# **Attachment A**

**Applicant's Submission**

**SUBMISSION TO PANEL – D/2024/782  
9-13 BOURKE ROAD, ALEXANDRIA**

3.2. PROPOSED MODEL 2 - GLAZING SPECIFICATIONS

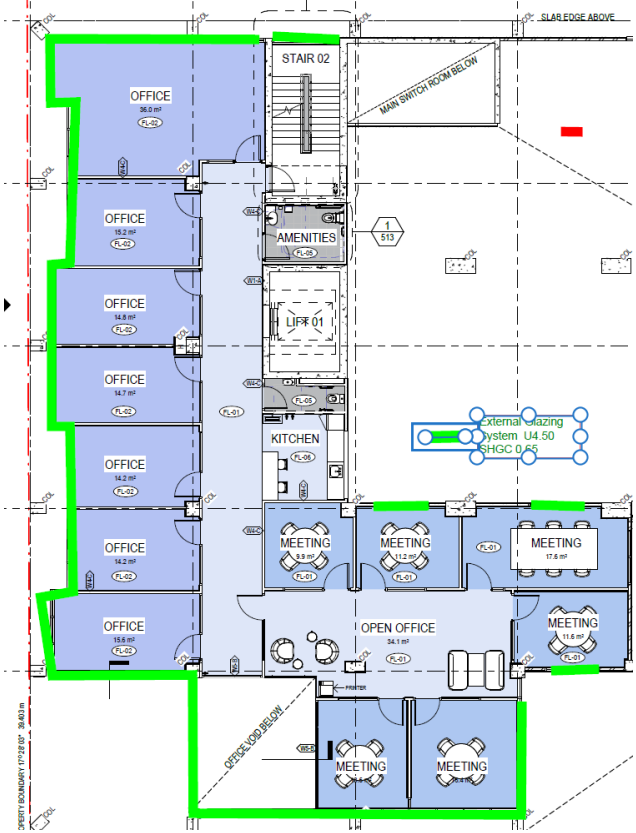
Condition 3(a) requests shading devices to the western and north-western windows at the ground floor and mezzanine levels. The Applicant submits that shadowing on these windows will effectively become redundant since new developments will be built as the locality redevelops and these will shade the subject site. Importantly, a Section J Report has been completed recently for the development which concludes that even double glazing would not be necessary for this development. An extract from this report has been provided to accompany this submission. It is requested that Council delete this design modification.

The total system (Glass infills + Frame) U-values and SHGC of glaze vision panels in Table 2 are to be achieved for the refurbished areas.

Items	Glazed Systems – Construction Specifications	Total System (including thermal bridging) (Frame + Glass) Allowable U-value (W/m2. K)	Total System (including thermal bridging) (Frame + Glass) Allowable SHGC
External Glazing	<p><b>New Glazed Façade – This typically would reflect use of Single glazed low-E glass + standard Aluminium Shopfront frame system.</b></p> 	≤4.50	≤0.65
